P&Z STAFF REPORT

Board of Appeals Meeting, February 11, 2020

Case: **V20-0003 – 1625 Sunnybrook Farm Road & 0 & 1220 Tynecastle Way NE**
Staff Contact: Madalyn Smith (msmith@sandyspringsga.gov)
Report Date: January 29, 2020

Case: **V20-0030 – 100 River North Court**
Staff Contact: Madalyn Smith (msmith@sandyspringsga.gov)
Report Date: October 14, 2020

SITE PLAN (received January 7, 2020) (full size Site Plan in Package)

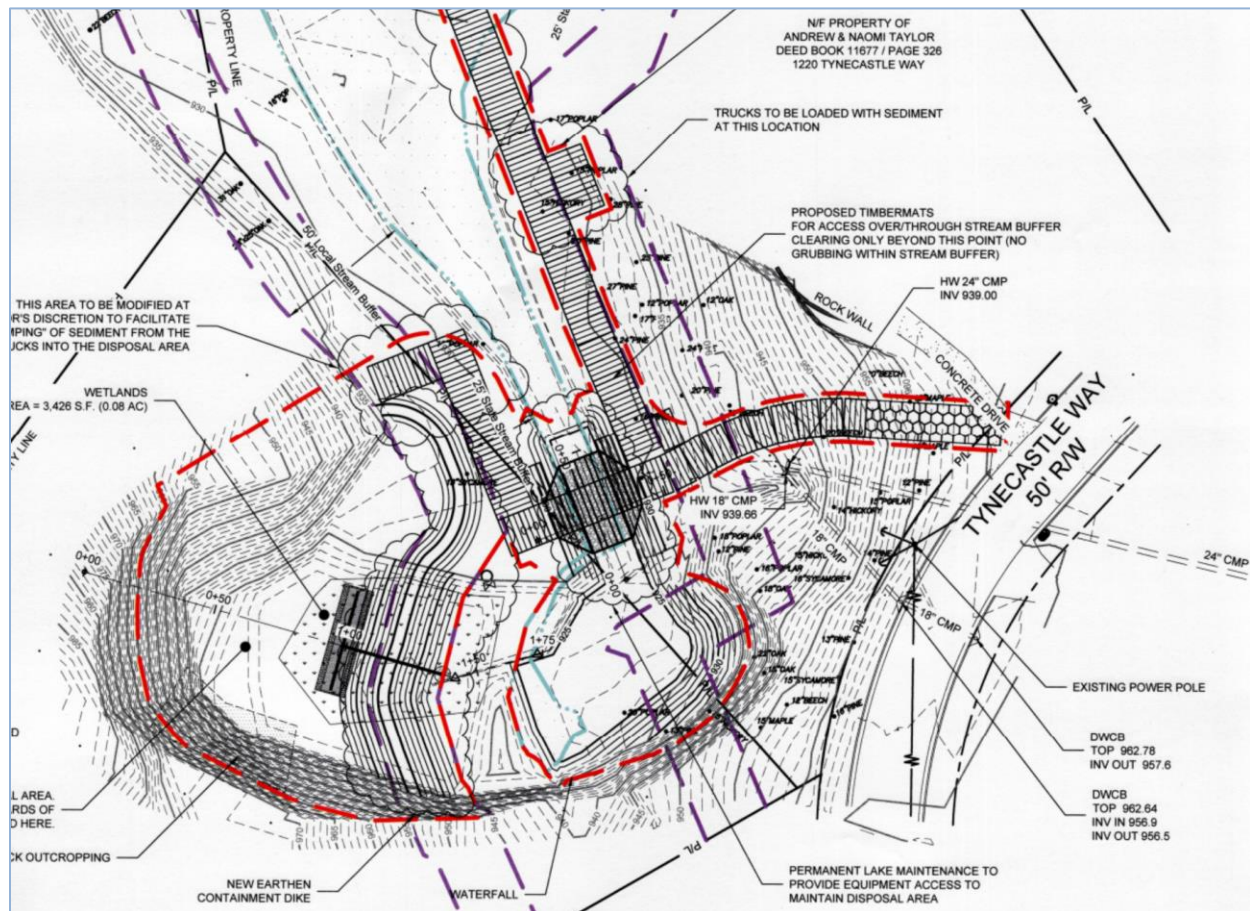
- This request is not necessary for the completion of the project. Soil can be disposed of off-site. The reasoning behind the request, as stated by the applicant, is financial.
- This request would permanently alter the 50-foot buffer, 25-foot setback, and a wetland. The impact of this project could not be effectively mitigated because naturally occurring wetland areas are not easily replaced or replicated.

The applicant's requests are two-fold. First is the request for intrusion into the 50-foot buffer and additional 25-foot setback, which would be required in order to access Lake Northridge for the dredging process. Second is the request for permanent alteration of the 50-foot buffer and additional 25-foot setback in order to allow the disposal of dredged sediment in a former quarry and current wetland.

The applicant has obtained the proper approval from the Army Corps of Engineers and the National Park Service for the dredging activities and to fill in an existing .08 acre wetland with the dredged material.

Staff recommends **Approval** of **Variance** V20-0003 Request #1.
Staff recommends **Denial** of **Variance** V20-0003 Request #2.

Limits of the wetlands area

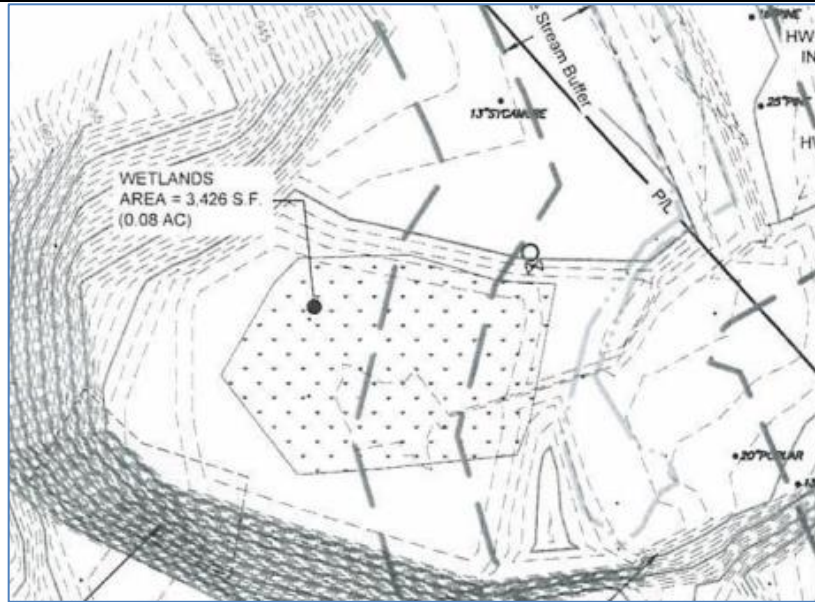
Finding: The 50-foot buffer and 25-foot setback area proposed to be disturbed is currently wooded and sloping. There is also a former quarry area with a sheer cliff. The quarry area has a 3,426-square foot wetland, as identified by the Army Corps of Engineers, which spans the buffer and setback area (see plan below).

Additionally, the applicant proposes a permanent alteration of the 50-foot buffer and 25-foot setback by disposing 2,000-3,500 cubic yards of dredged sediment. This disposal area would also fill in the wetland area and former quarry. No upland areas have been identified as possible alternative dumping/deposition areas.

However, it is Staff's belief that disposal of sediment within the 50-foot buffer, 25-foot setback, and wetland should not be permitted. Granting a Variance to allow the applicant to permanently alter the buffer and remove a wetland would not be protective of natural resources and the environment and would go against the stated purpose of the State Waters Protection division of the Development Code which is to "[Protect], [restore] and [maintain] the chemical, physical and biological integrity of streams and their water resources." A wetland within the 50-foot buffer and 25-foot setback is a good resource. After filling in/removal, the benefits of wetlands such as the positive impacts on water quality, wildlife habitat, and ecosystem productivity could not be recreated by revegetating the area.
